STUDY SESSION STAFF REPORT

CASE NO.: UP-08-012

OWNER: GILEAD SCIENCES

PROJECT LOCATION: VINTAGE PARK – 331 LAKESIDE DRIVE - APN: 094-904-320,
(NEIGHBORHOOD VP-VINTAGE PARK)

A5 FACADE TREATMENT-CONTINUED

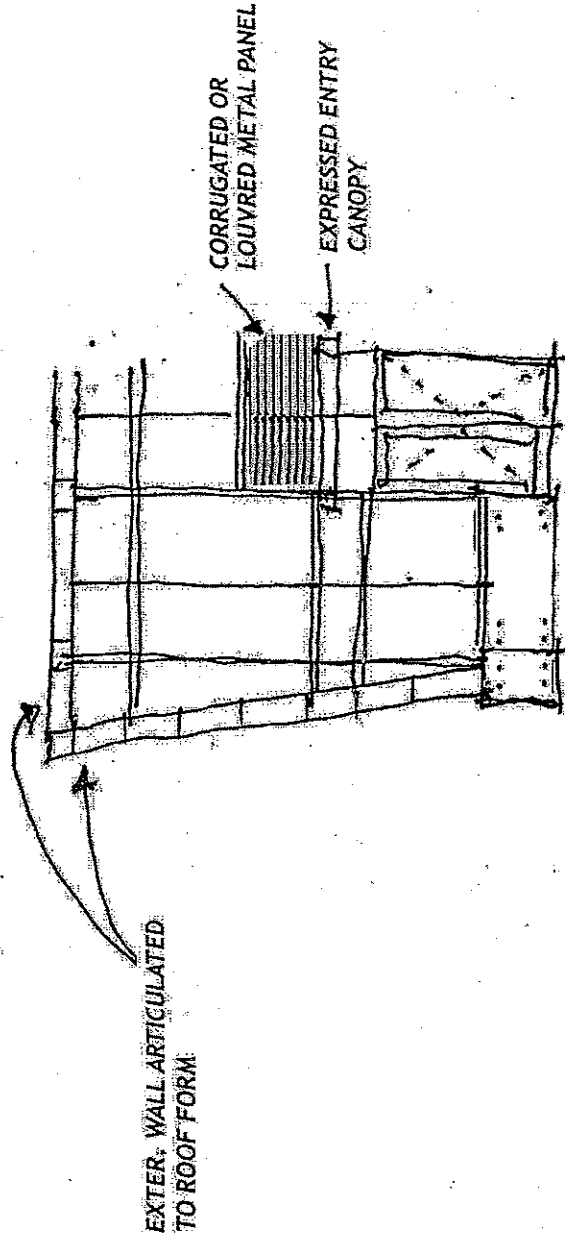
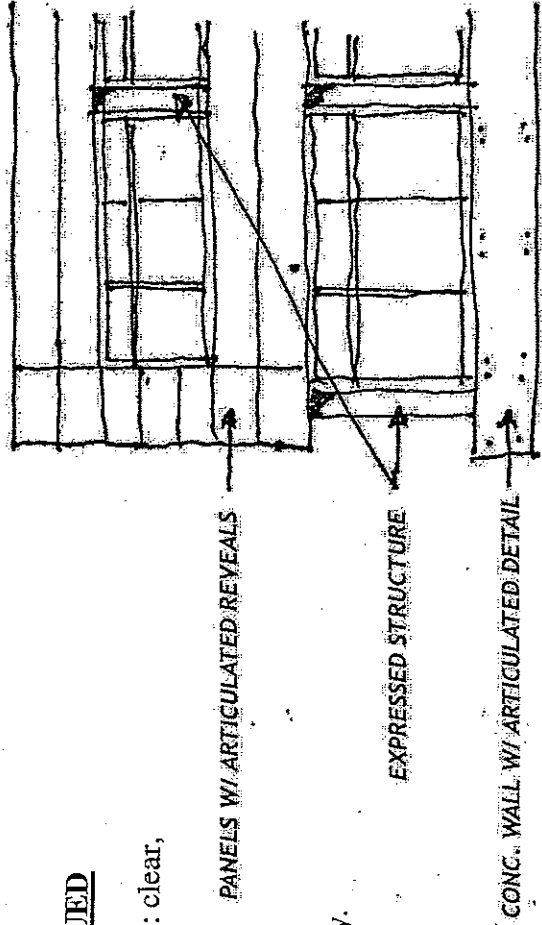
Replace Text "Acceptable glazing colors are: clear, reflective or gray" with

- Unacceptable glazing colors are: bronze, gold/yellow and rose.
- Acceptable glazing colors include: Blue, green, reflective, clear and gray.

A5 FACADE TREATMENT CONTINUED

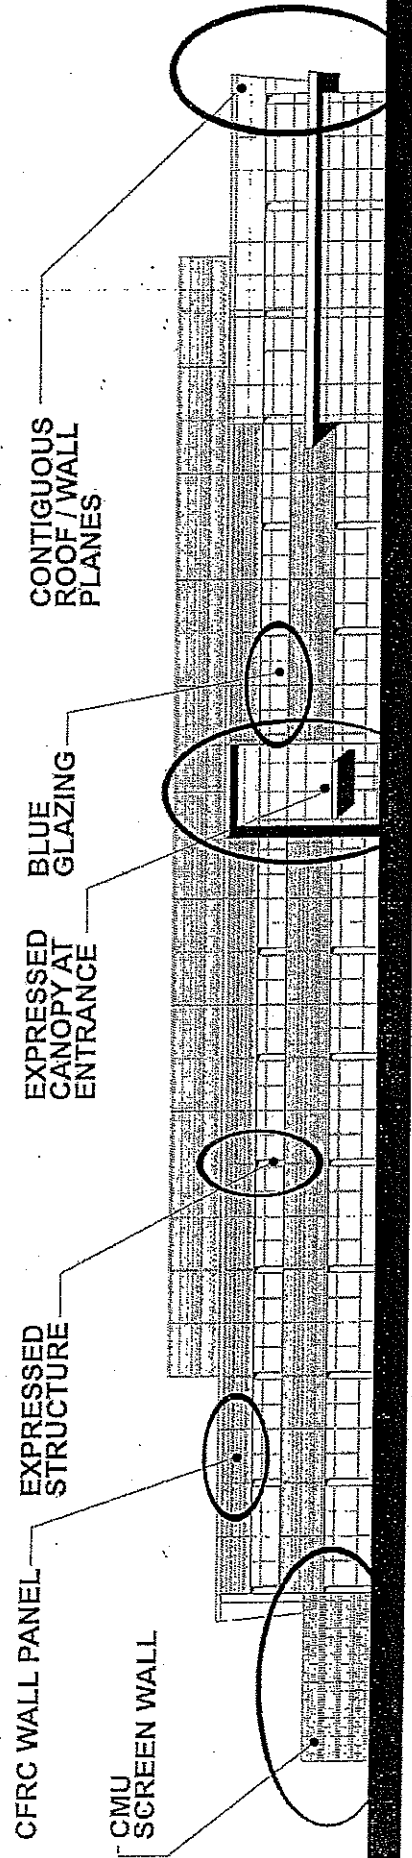
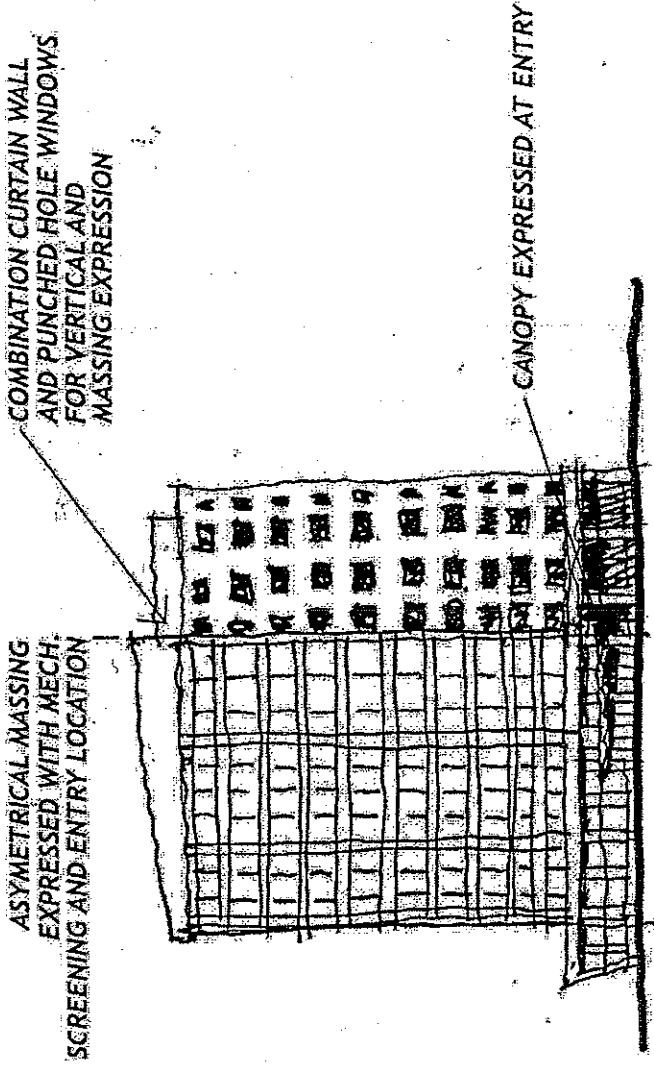
Replace Text

“Examples of unacceptable exterior materials:

Brick or concrete block.

Rough textured stone veneer.

Wood siding.” with

- Examples of acceptable exterior materials:

Polished / honed stone veneer.

CFRC panels.

Composite Metal or Clad Resin panels.

- Examples of unacceptable exterior materials:

Brick or concrete block – *except at Screen walls for equipment, trash etc.*

Rough textured stone veneer. – *except as accent at building base*

Wood siding – *except for wood panels as accents within a facade of regularly articulated panels of other primary material (metal panels, GFRG etc.)*

C5 FACADE TREATMENT

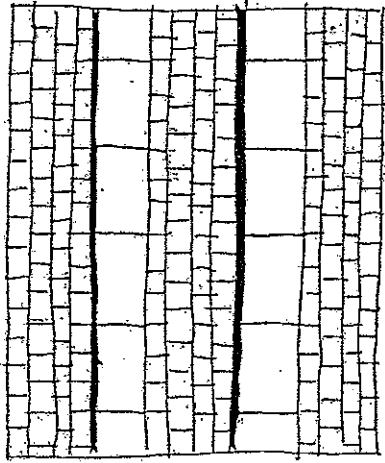
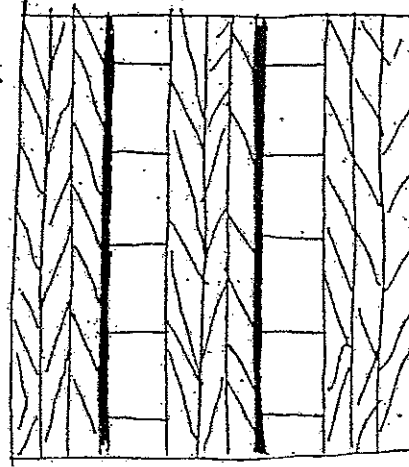
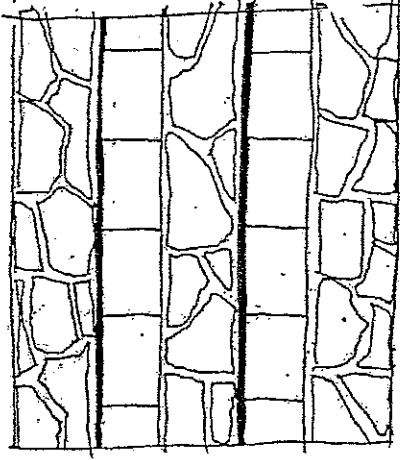
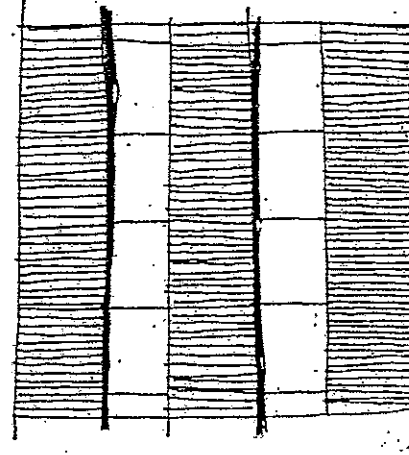
Replace Text

- "Examples of unacceptable exterior materials:
Brick or concrete block.
Rough textured stone veneer.
Wood siding." with
- Examples of acceptable exterior materials:

Brick or concrete block – *except at Screen walls for equipment, trash etc.*

Rough textured stone veneer. – *except as accent at building base*

Wood siding – *except for wood panels as accents within a facade of regularly articulated panels of other primary material (metal panels, GFRC etc.)*

NO* SEE EXCEPTION IN TEXT

NO* SEE EXCEPTION IN TEXT

NO* SEE EXCEPTION IN TEXT
